R19ZV

DATE: May 31, 2019
TO: Blue Bird Owners
Subject: R19ZV, Vision Transmission Shifter Cable & Brake Line Routing with Ford 6.8L V10 Engines

SUBJECT: RECALL R19ZV – Vision Transmission Shifter Cable and Brake Line Routing with Ford 6.8L V10 Engines

R19ZV Revision A Vision Trans Shifter Cable & Brake Line

Photo 1

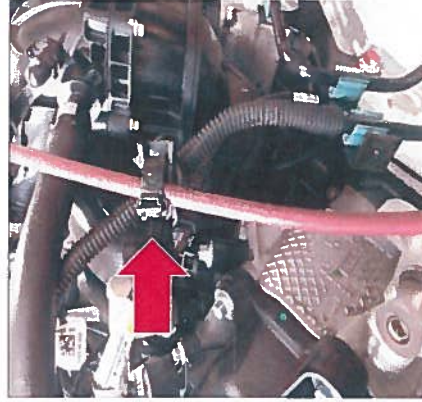
Check the transmission shifter cable and insure it is NOT mounted to the top rear of the engine (Photo 1). Also inspect the fuel line to insure the PCV hose is not attached to the fuel line (Photo 2). If so, cut the mounting cable ties and remove ties and mounting saddle. Inspect the fuel line for any chaffing at shifter cable mounting point and replace fuel line if necessary.

Figure 1

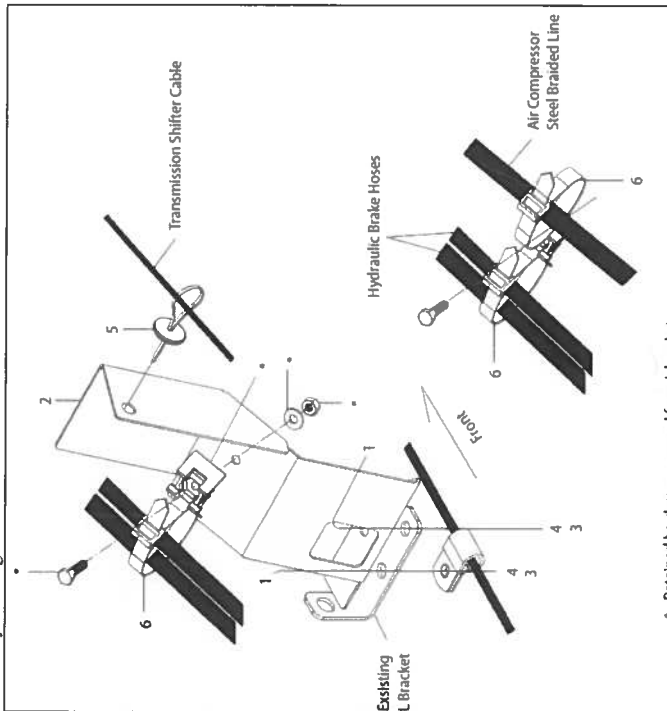
4. Locate the existing steel brake line L bracket mounted to the inside of the LH frame rail. Remove and retain the hydraulic brake line clamp, two-way saddle and fasteners from the top of the L bracket (Figure 1).

5. Install heat shield bracket (Item 2) to the top of the L bracket with fasteners (Items 1, 3, 4) and remount the metal brake line clamp under the existing L bracket (Figure 1).

- Please insure steel brake line is clamped in a parallel line to the frame rail.
6. Install the previously removed two-way saddle containing the rubber hydraulic brake line to the heat shield using the existing fasteners as shown (Figure 1).

7. On units with an air compressor, secure the air compressor steel braided line to the heat shield saddle with an additional tie cable (Item 6) separate of hydraulic brake lines as shown (Figure 1).

- Verify the routing of the braided line to insure no dips in the line with a continuous downward slope to the air dryer.
8. Secure the transmission shifter cable to the side of the heat shield with button head zip tie (Item 5) as shown (Figure 1).

Figure 2

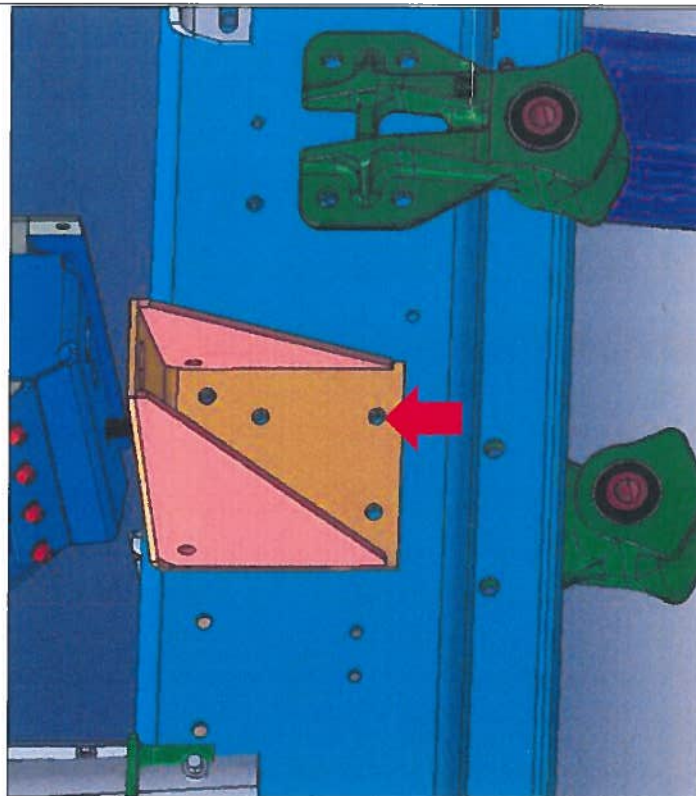
1. Locate and remove lower rearward Huck fastener from driver's side outrigger bracket. Indicated with small red arrow (Figure 2).
2. Install L bracket (Item 7) with fasteners (Items 8, 9, 10) on the inside of frame rail in the location of the removed Huck fastener. Torque to 56-58ft lbs.

Figure 3

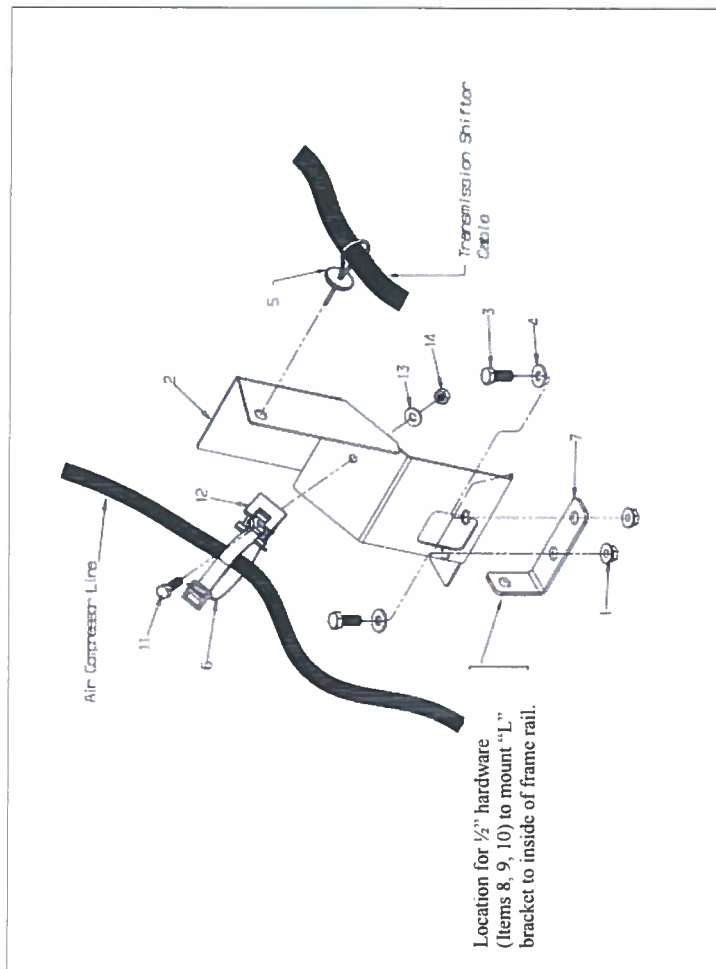
3. Install heat shield bracket (Item 2) to the top of the L bracket with fasteners (Items 1, 3, 4) as shown (Figure 3).
4. Install Saddle (Item 12) to the heat shield with fasteners (Items 11, 13, 14) as shown. Secure the air compressor steel braided line to the heat shield saddle using Zip Tie (Item 6) as shown (Figure 3).

- Verify the routing of the braided line to insure no dips in the line with a continuous downward slope to the air dryer.
5. Secure the transmission shifter cable to the side of the heat shield with button head zip tie (Item 5) as shown in (Figure 3).
